Ms. Karen Parsells, Principal
Marlborough School
23 School Street
Marlborough, New Hampshire 03455

Re: Playground Inspection

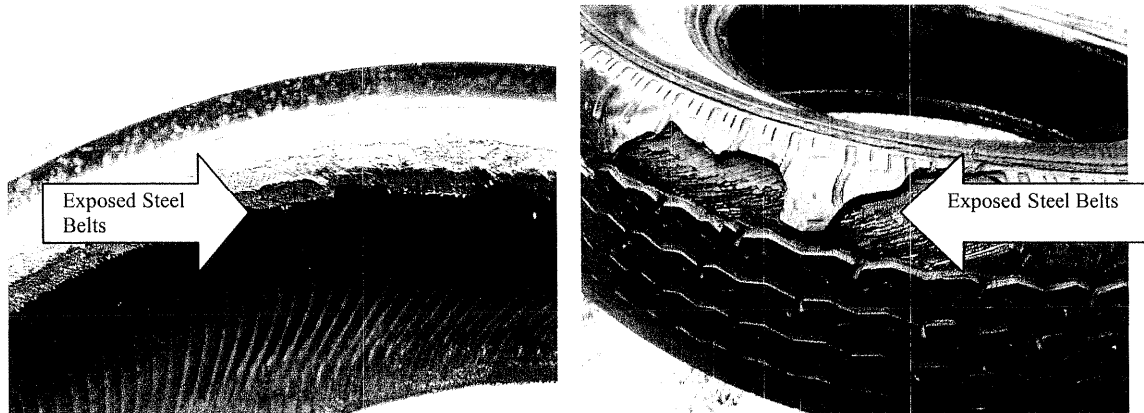
- ♦ The tire swing has several tires where steel belts are exposed creating a significant potential for a laceration. The tires should be replaced or removed immediately to minimize this risk. Additionally, the use zone around this piece of equipment is not adequate. This is one area where the surfacing material is not adequate in depth (6 inches), and there is not enough room around the swing (6 feet).

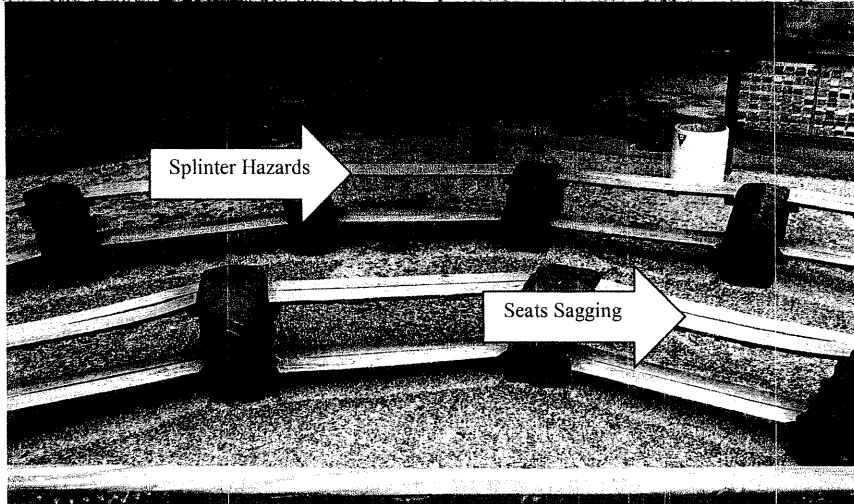
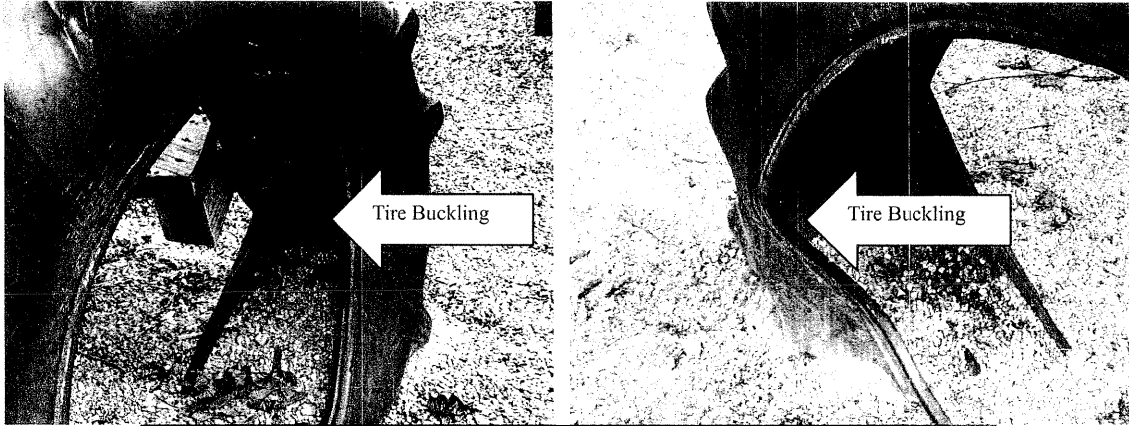
- ♦ The tires that support the amphitheater seating are weakening due to age, and are at risk of collapsing under the weight of several occupants. This is a concern since the tires are exposed underneath the seats, and a child could be inside a tire when it collapses. This structure should be removed or the tires replaced as soon as possible. There are also areas where the wood is splitting, and could break and there is a potential for splinters as well.

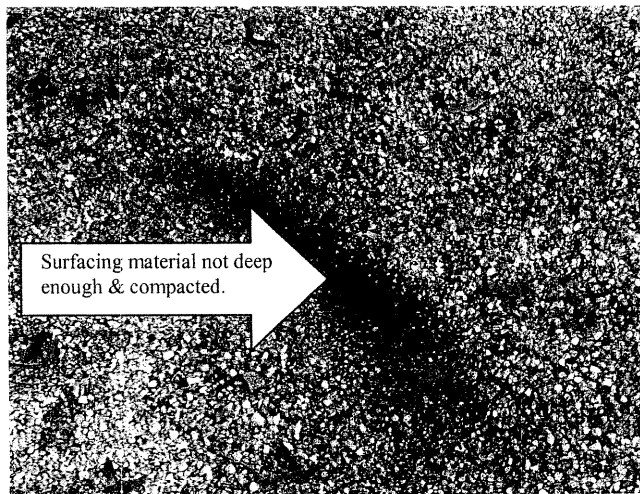
- ◆ Surfacing material needs to be added under the climbers to a depth of nine inches (9") based on the height of the climbers. The existing material should be tilled first, then additional material added to secure the proper depth.

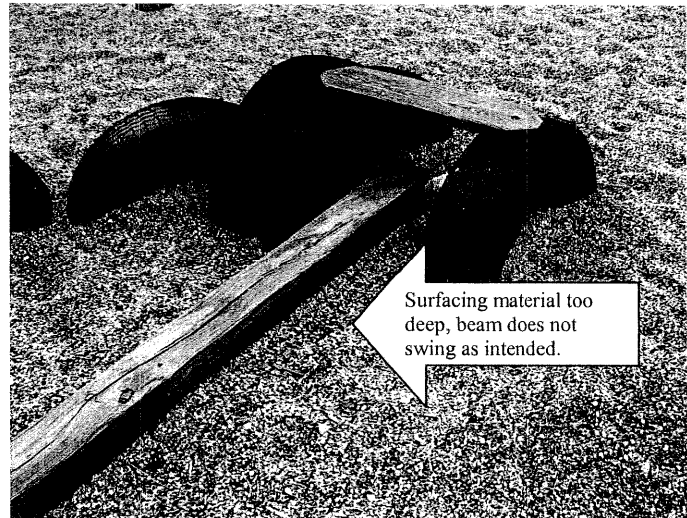
- ♦ The swinging balance beam (ground element) has too much surfacing material under it causing it to not operate properly. It is recommended that the surfacing material be removed to a depth of 5 inches under the beam to allow for the element to swing as intended.

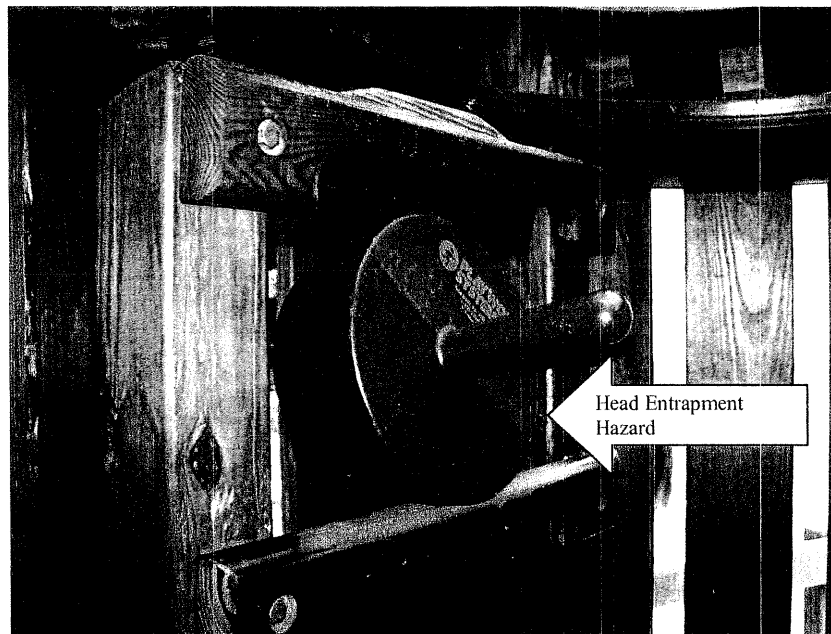
- ♦ The top step inside the castle climber is a potential head entrapment hazard due to the close spacing of the top two rungs of the ladder. It is recommended that the steps be separated to greater than nine inches (9") but not more than 15 inches (15") apart.

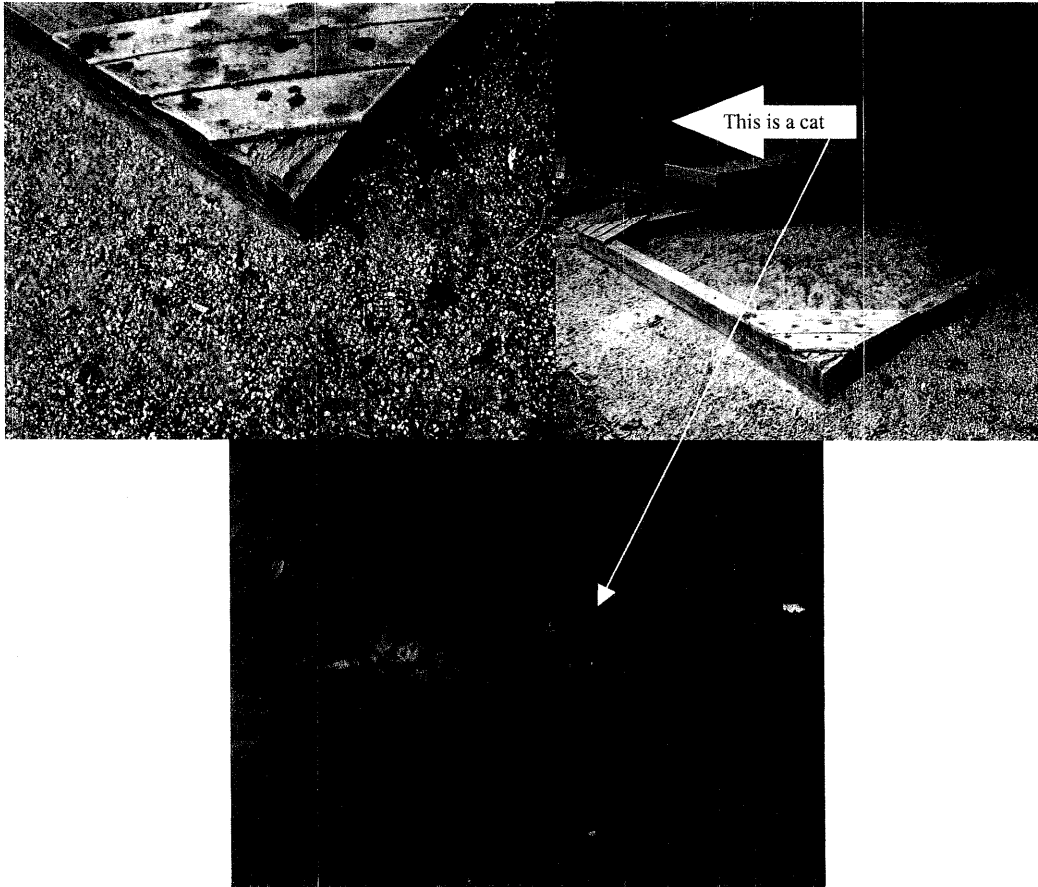
- ♦ The sandbox has several areas where splinters are a potential hazard. Additionally, sand boxes should be checked regularly for animal feces (raccoons, cats...), and removed as necessary. If this is a regular occurrence, consideration should be given to covering the sandbox when not in use.

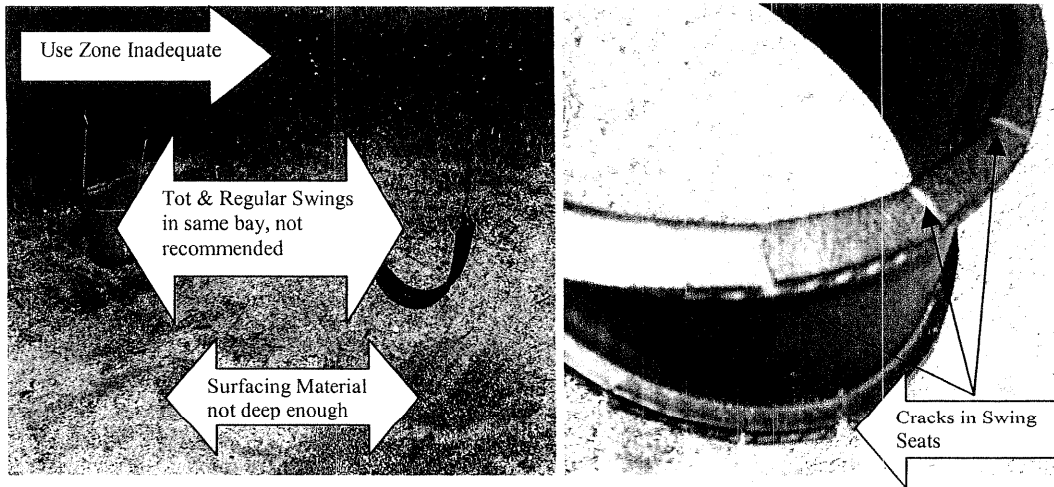
- ♦ The use zone for the swings is inadequate and should be extended to include six feet out from each end of the swing set and 20 feet in front of and behind the swings based on the 10-foot height of the pivot point. Several swing seats are cracked and should be replaced as soon as possible, and the spacing is not compliant with ASTM/CPSC Guidelines (swings should be at least 24 inches apart, and 30 inches from the swing structure). Also, tot swings are not recommended in the same bay as regular swings.

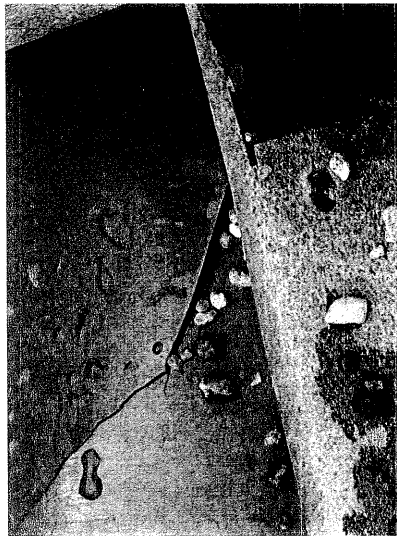
- ♦ There is a crack in the plastic at the top of the slide that should be repaired immediately to prevent the risk of an entanglement hazard.
